REV. NO.	DESCRIPTION	BY	DATE	APPROV.
4	MADE CORRECTIONS BY MARKED UP PRINT BY ANDY SMITH AND DALE GRIGGS	MB	7/8/81	
4	REVISED DWG. PER AS-BUILT INSTALLATION	JT	11/9/82	
5	REVISED DIMENSIONS OF PLATE AT WING BOTTOM FR. 22. REVISED SHIPS THICKNESS FR. 22. ADDED DETS. FR. 26 & 28 (AS-BUILT). ADD SEE DETAIL BTWN ATTACHED TO W.T.BK. STEM & PAINTED THICKNESS TO AS BUILT. REV. A. WING, W.T. ABS. 3.1 MARS 1981	JT	8/4/81	
6	MADE CHANGES TO FR. 6, 7, & 8 (FR. 7) TO MATCH TRIAL FITTING DRAWING 70 RUN THRU REV. DR. 84 AND SIDE 20-83.	JT	8/4/81

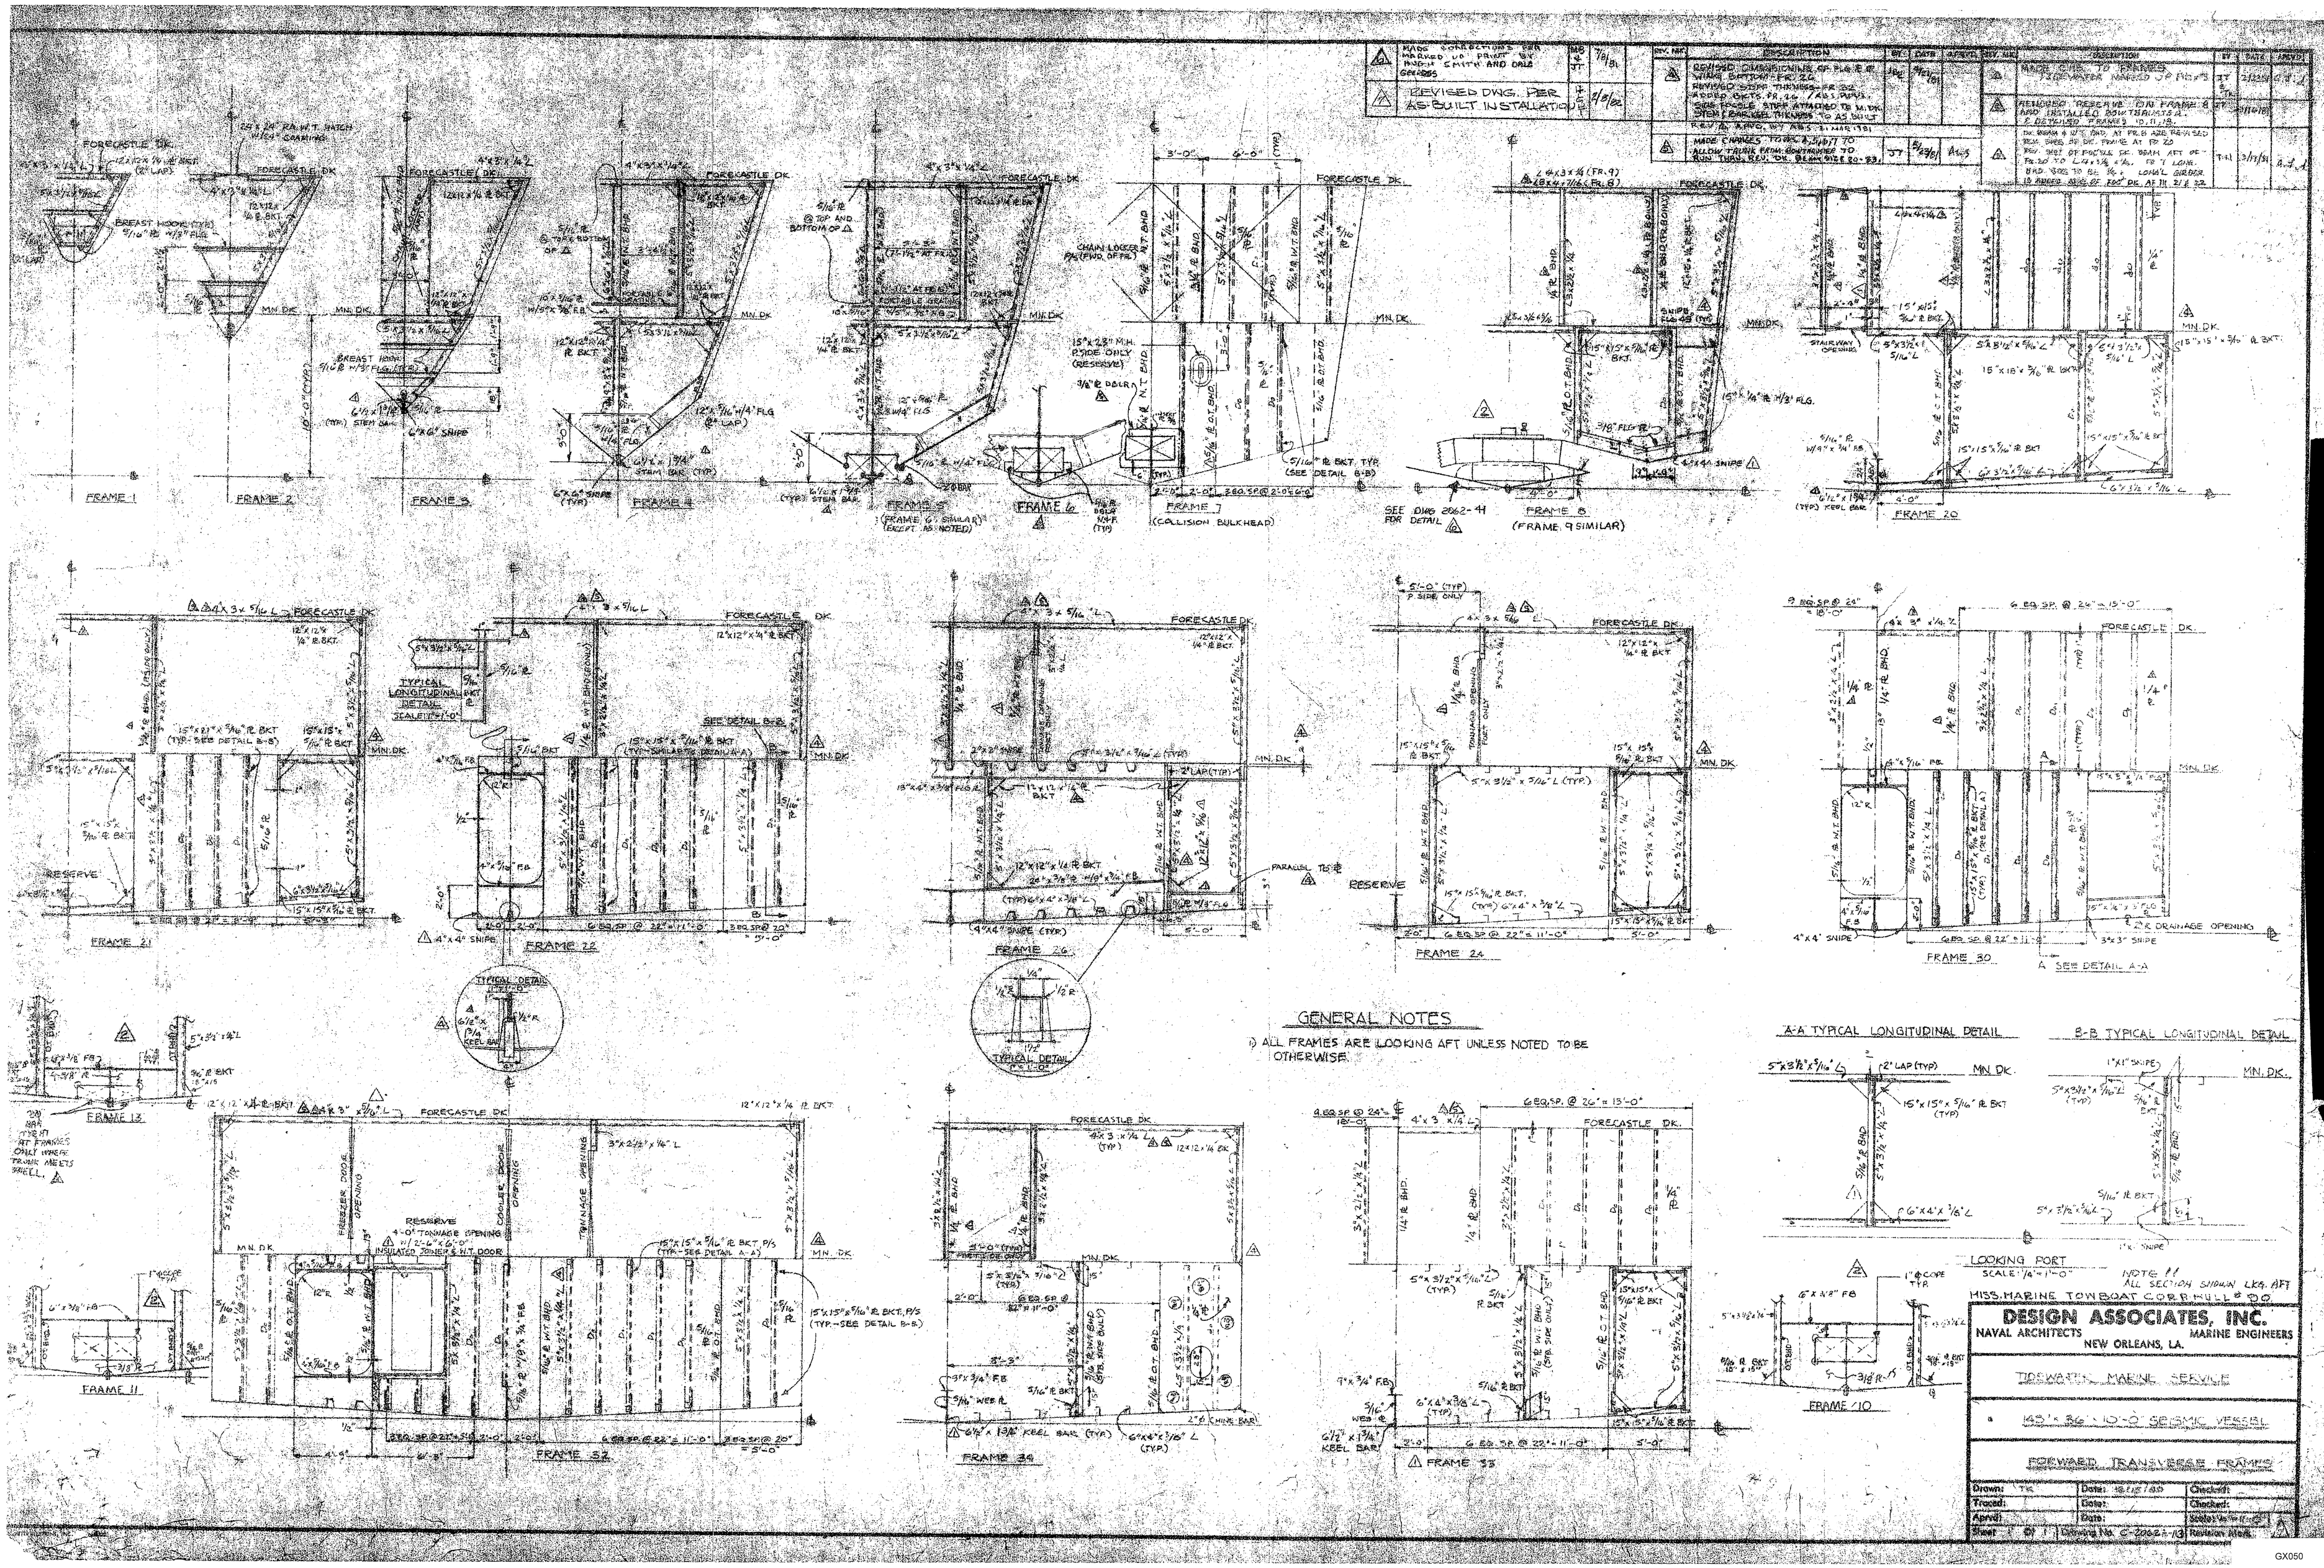
REV. NO.	DESCRIPTION	BY	DATE	APPROV.
4	MADE CHG. TO FRAMES 20 & 22 (WATER MARKED UP PRINT)	JT	3/12/80	
4	REMOVED RESERVE DIA FRAME 8 AND INSTALLED 20" WATERTIGHT A.T.F. DETACHED FRAMES 10, 11, 13.	JT	3/11/80	
3	DR. DRAW & UPD. IND. AT FR. 8 AND REVISED REV. SHEE. 8 DR. FRAME AT FR. 20. REV. SET OF FACTUAL DR. 1984 (AFT OF FR. 20) TO L=4 1/2 & 1/4". FR. 7 LONG. IND. 3.00 TO 6.0. 1/4" LONG'L GIRDER IS FRAMES 8 & 9 AT DR. AT FR. 21 & 22.	TAL	3/11/81
